# CHUITNA COAL MINE

Subject: Minor Modification to Permit Number 02-83-795

**Re: ASCMRA Exploration Permit 02-83-795  
Minor permit revision request**

## Proposed Exploration Permit Revision ASCMRA Exploration Permit 02-83-795

FIGURE 1 – Drillhole Locations and Proposed Project Access

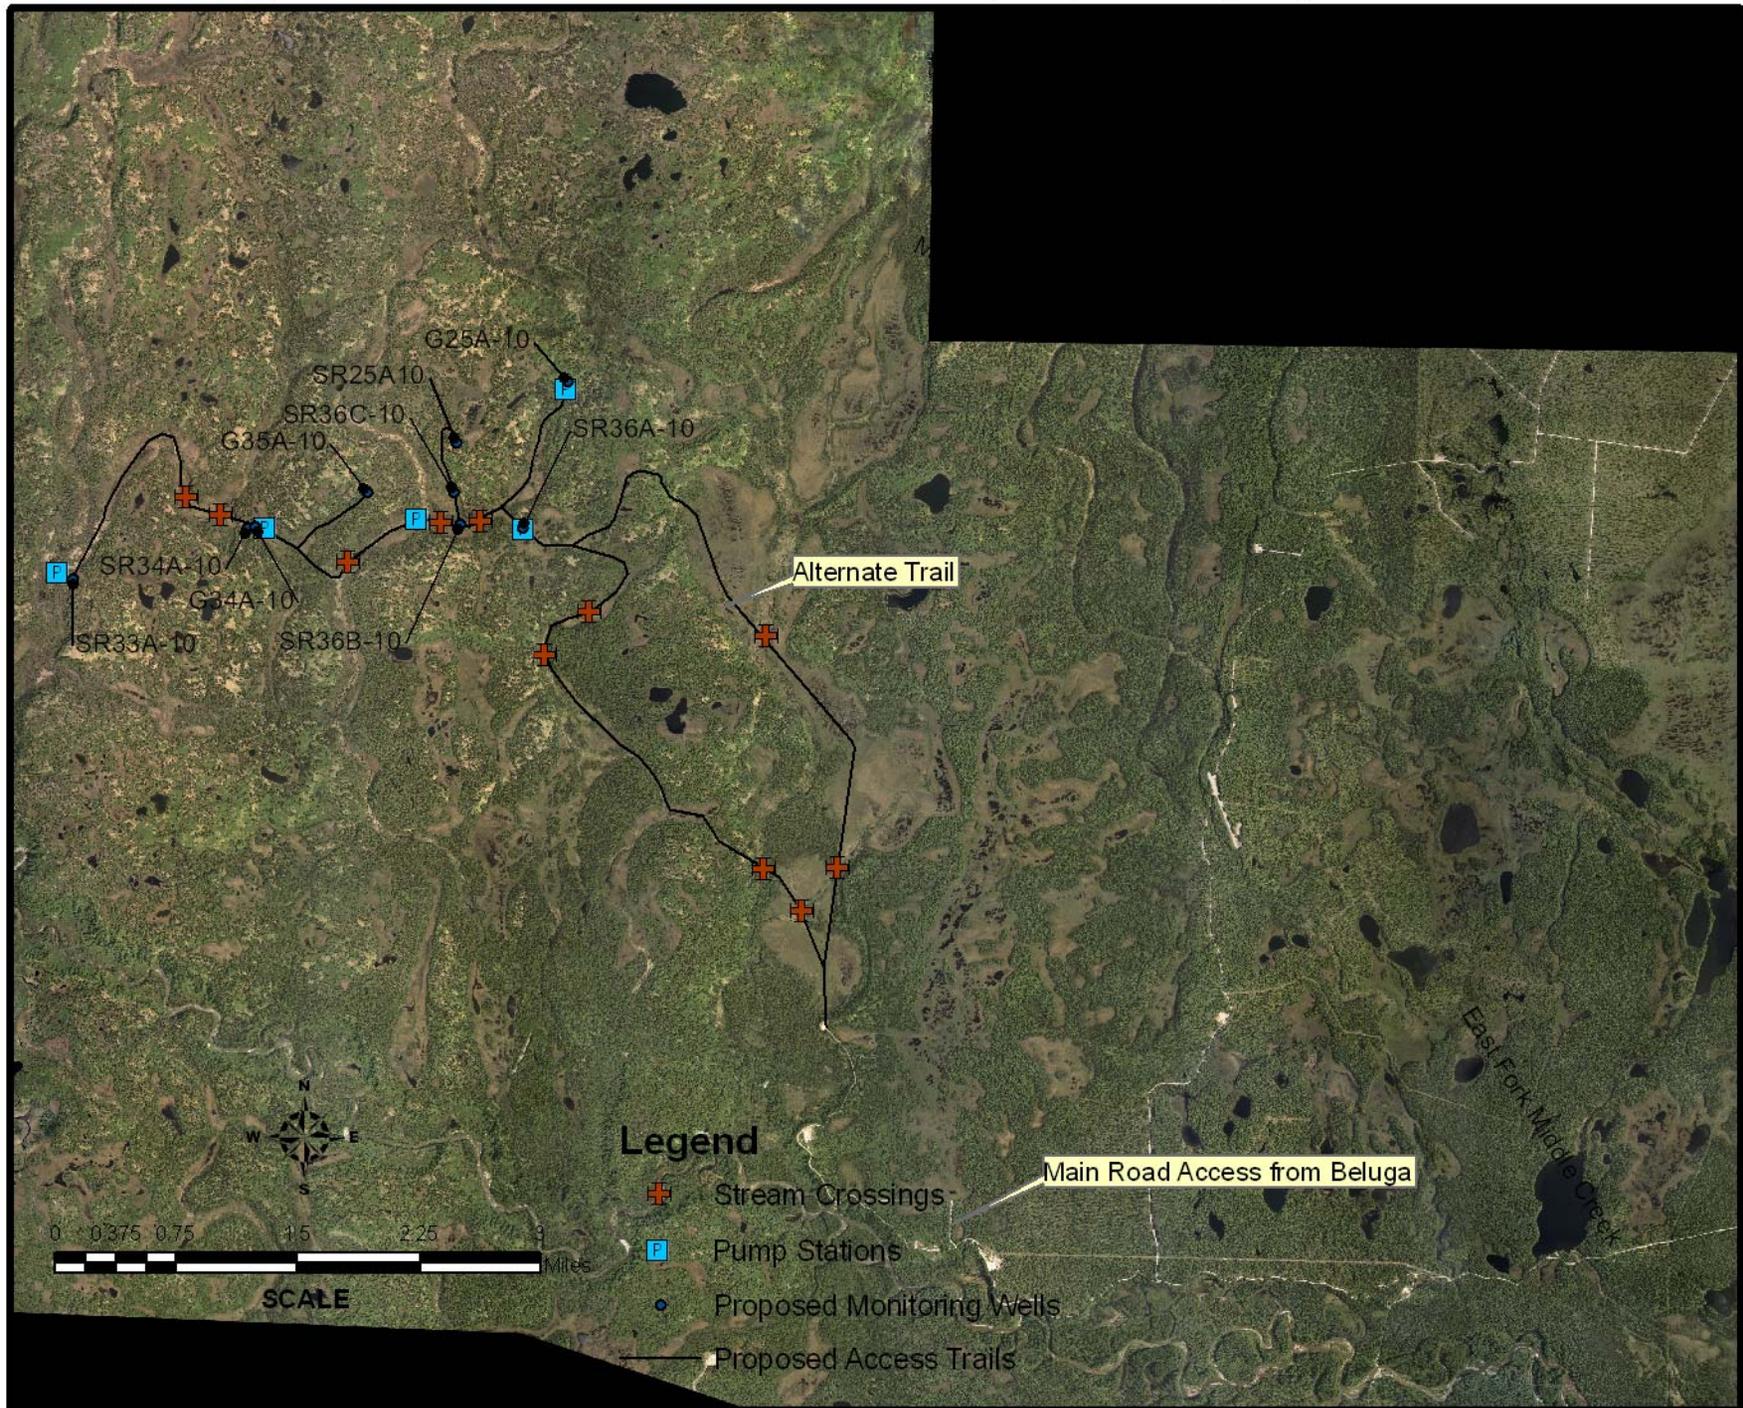
PRC is considering installing up to 10 monitoring wells as shown on the Table 1 below. The hole locations are also shown on Figure 1, Drillhole Locations and Proposed Project Access, and Figure 2, Detailed Hole Locations with Site Topography. The primary purpose of the wells are to (1) gather additional hydrologic data from the Sub-Red 1 Sand unit south of the south pit fault, and (2) obtain additional water quality data from the Glacial Drift unit in the project area. Maximum hole depth is anticipated to be 400 feet below ground surface (BGS).

The holes depicted in Table 1 and on Figure 1 were selected based on the existing geologic model. Nearly all holes were selected as twin holes to previously drilled holes from geologic investigations. The hole will be co-located on or near the previous drilling site as best practical. PRC reserves the right to make field adjustments as required to achieve the desired goals based on conditions encountered in the field.

For daily access of the drill crew, fuel and supplies, PRC proposes to use a crawler mounted carrier made for off-road travel. This will use the same trail system as the drill and will have minimal if any ground disturbance. The preliminary trail system is shown on Figure 1, subject to modification based on field conditions. Crews, housed off site at existing commercial facilities, will travel from the lodging to the end of the road system via pick-up trucks. Snow machines will be available at the drill site each day as an alternate access measure for emergency situations or intermittent travel during the shift.
